MONTEREY PENINSULA WATER MANAGEMENT DISTRICT

**ADDENDUM NO. 3
TO
CONTRACT DOCUMENTS**

**For Construction
Of
SANTA MARGARITA SITE BACKFLUSH BASIN EXPANSION PROJECT**

Drawing No:
FIGURE 1

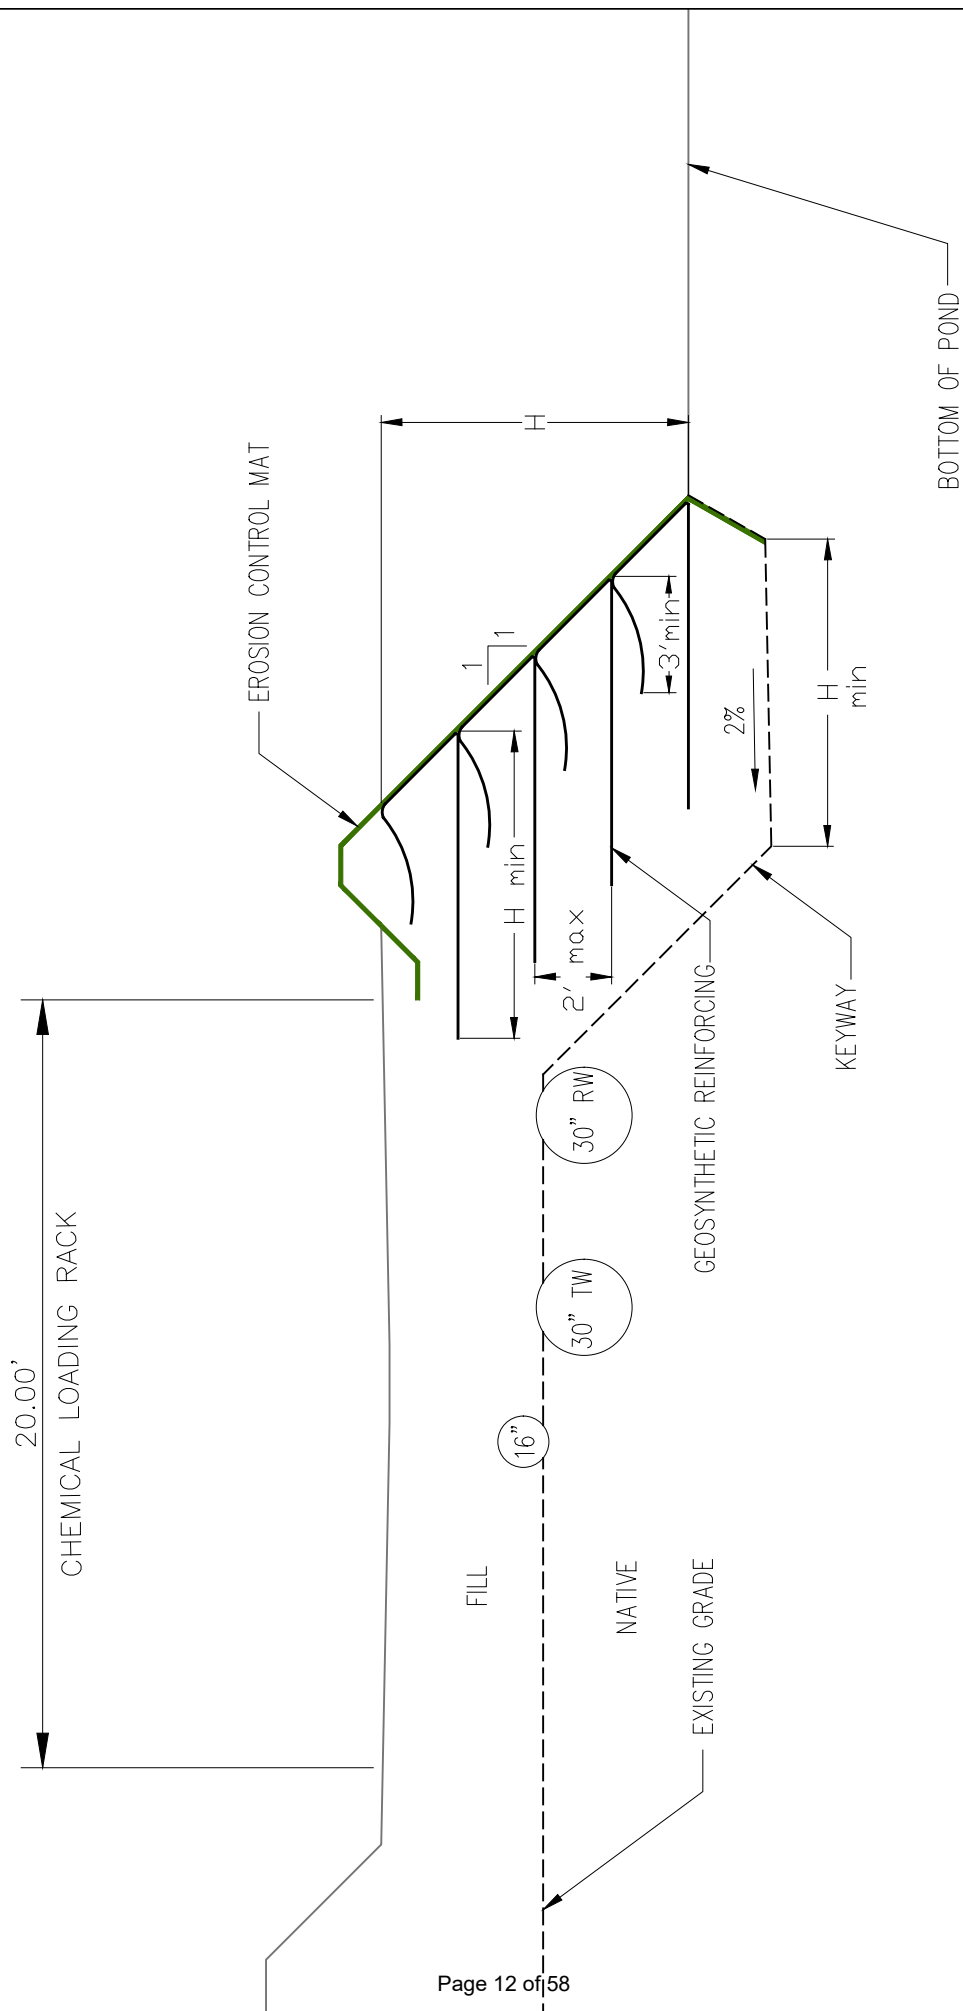
The proposed pond expansion will require raising existing grades along the north and west sides with up to 4 to 5 feet of fill. In addition, existing grades at the base of the expanded pond will be lowered by about 5 to 6 feet. This will create a condition where the pond slopes will be comprised of cut overlain by fill. As recommended in the soil report, fill slopes to be constructed above cut slopes should be set back a minimum of 8 feet horizontally from the top of the cut slope. This is especially important where structural improvements such as the chemical loading rack, new access roads or new utility corridors will come within close proximity to the pond slopes. Alternatively, the slope below the chemical loading rack pad may be constructed of engineered fill at a maximum gradient of 2:1 horizontal. The fill slope should be constructed in accordance with the recommendations of the 2009 geotechnical report and Figure No. 1 attached.

Bid Drawings, Drawing A111

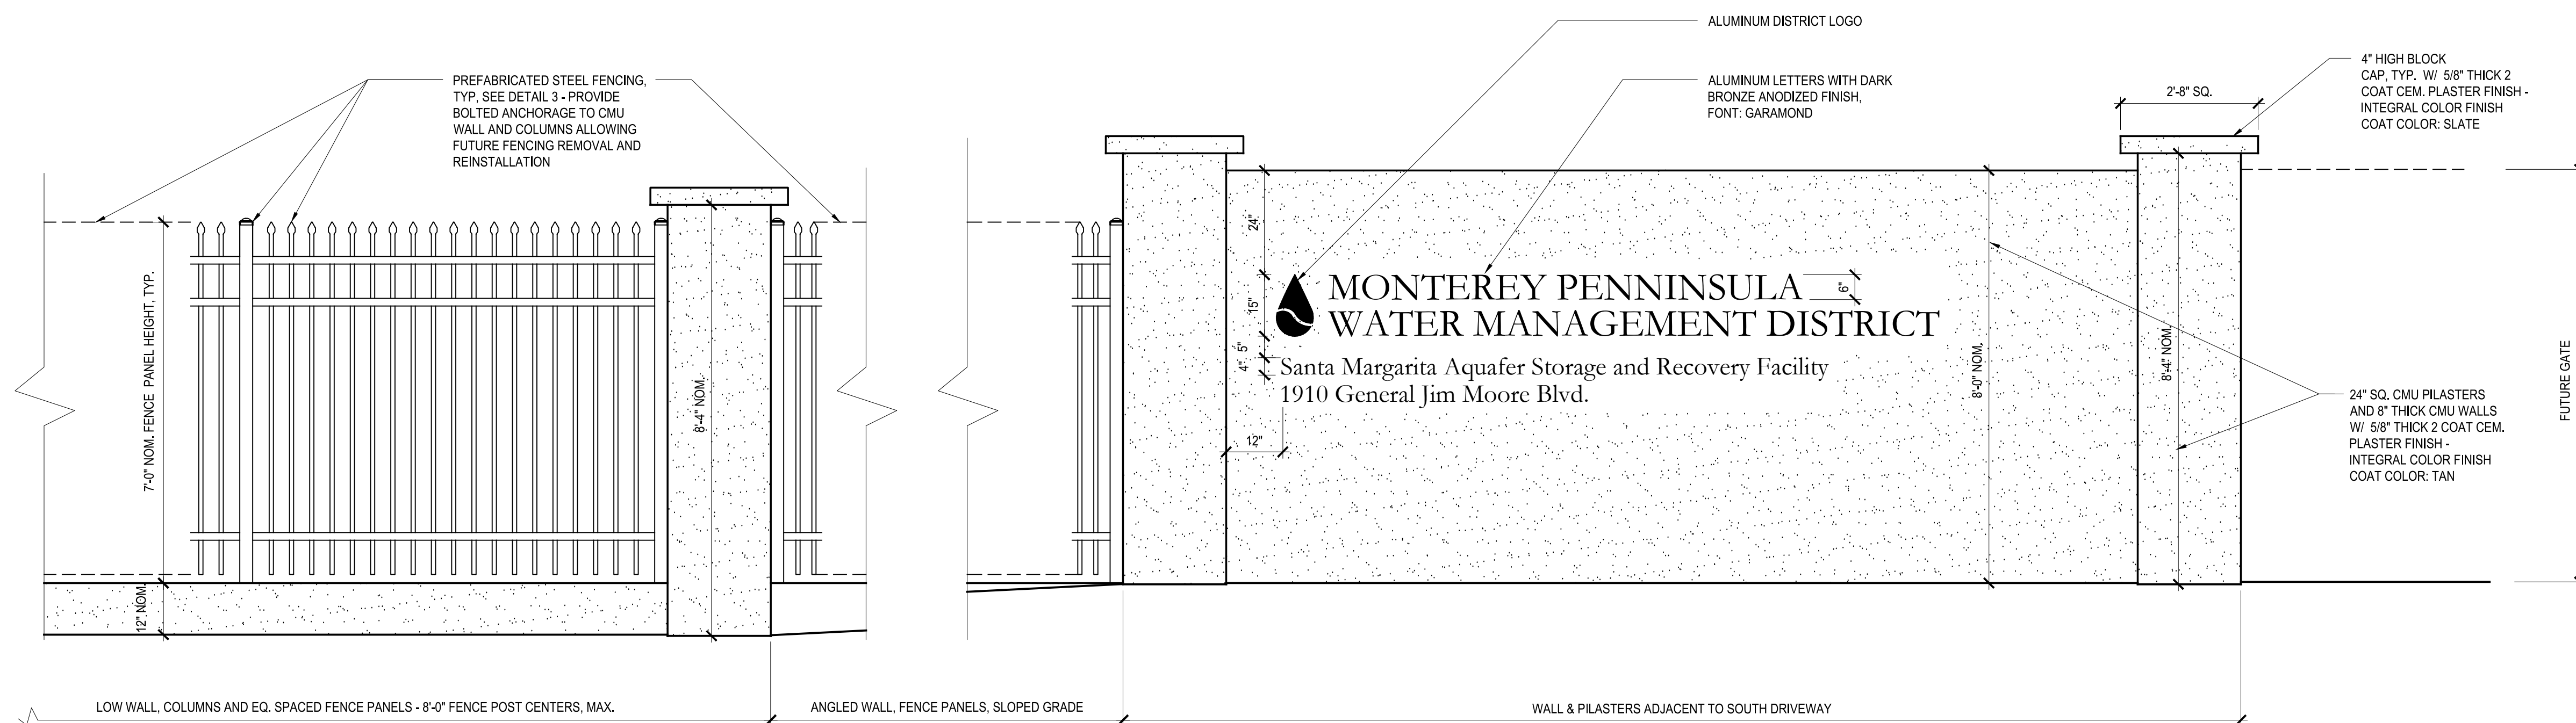
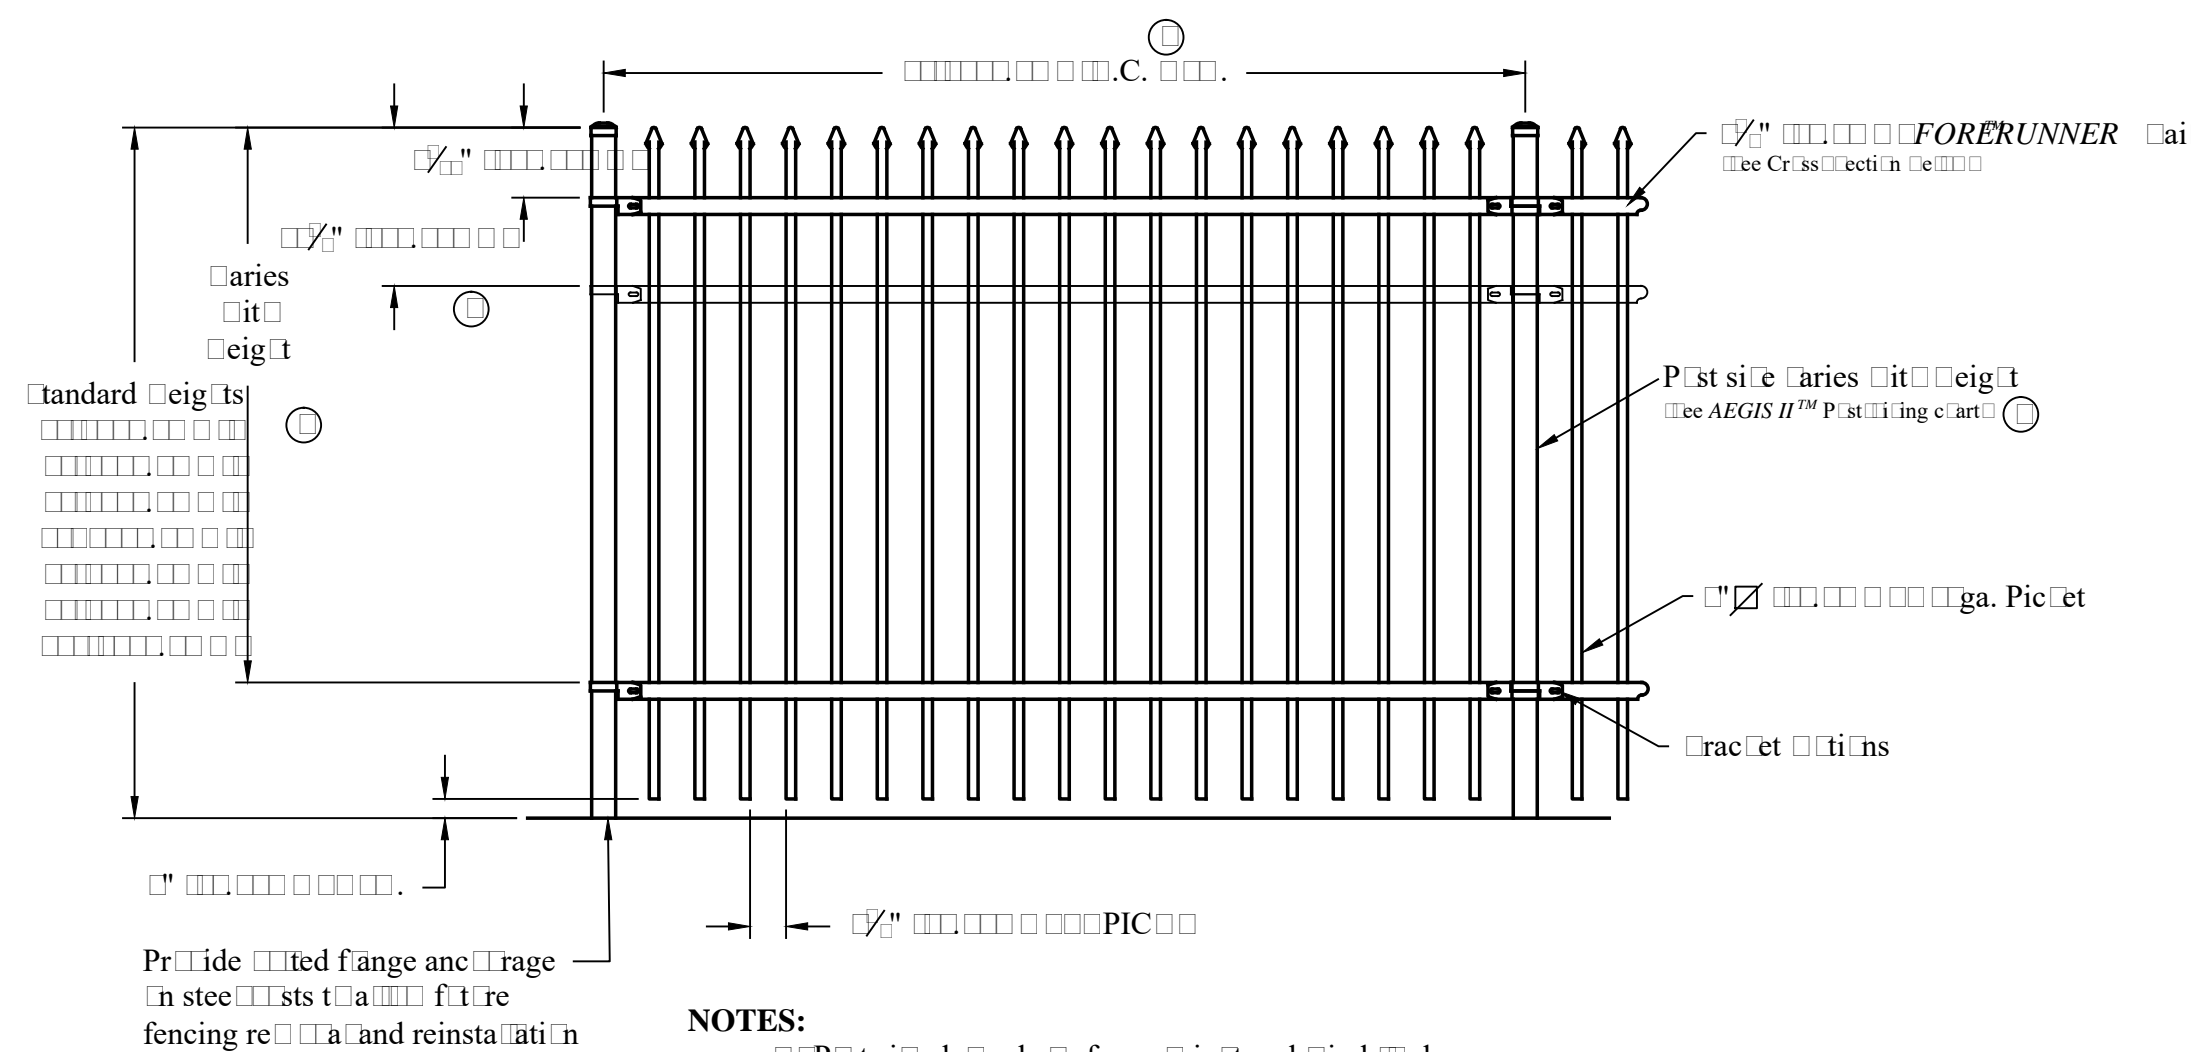
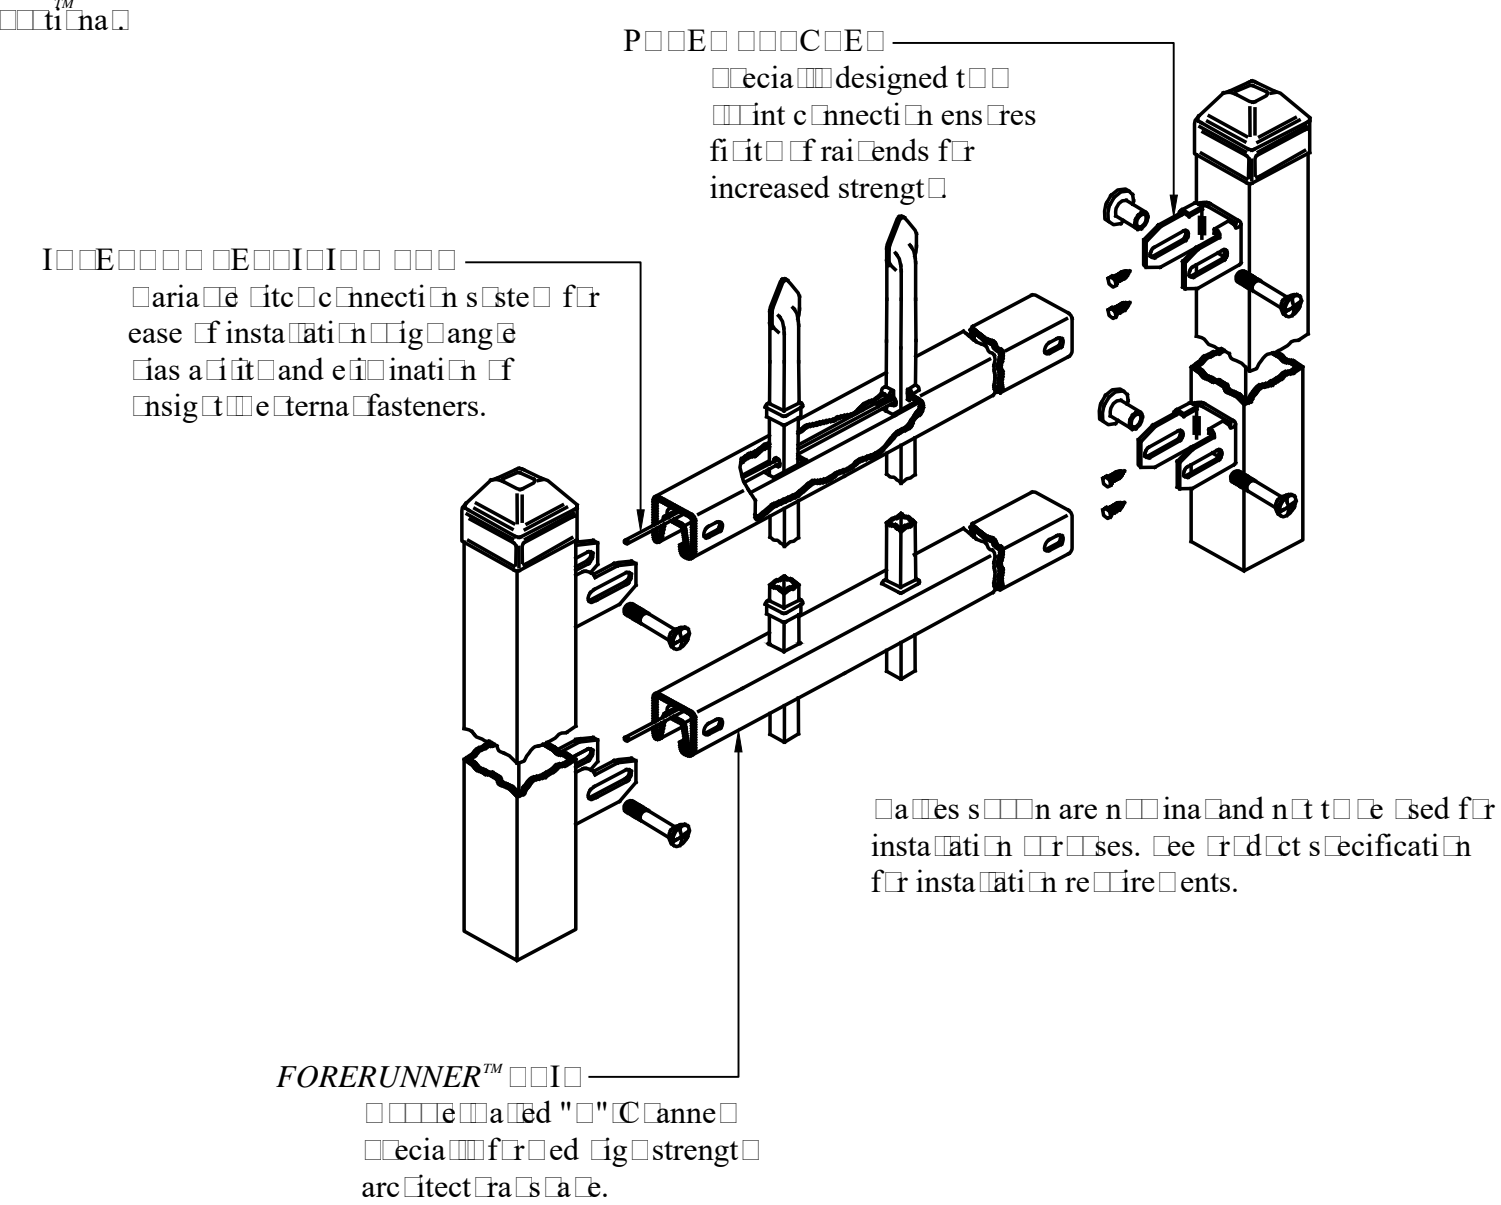
Delete the drawing in its entirety and replace with the drawing A111 dated June 26, 2018 provided in **EXHIBIT C** of this Addendum.
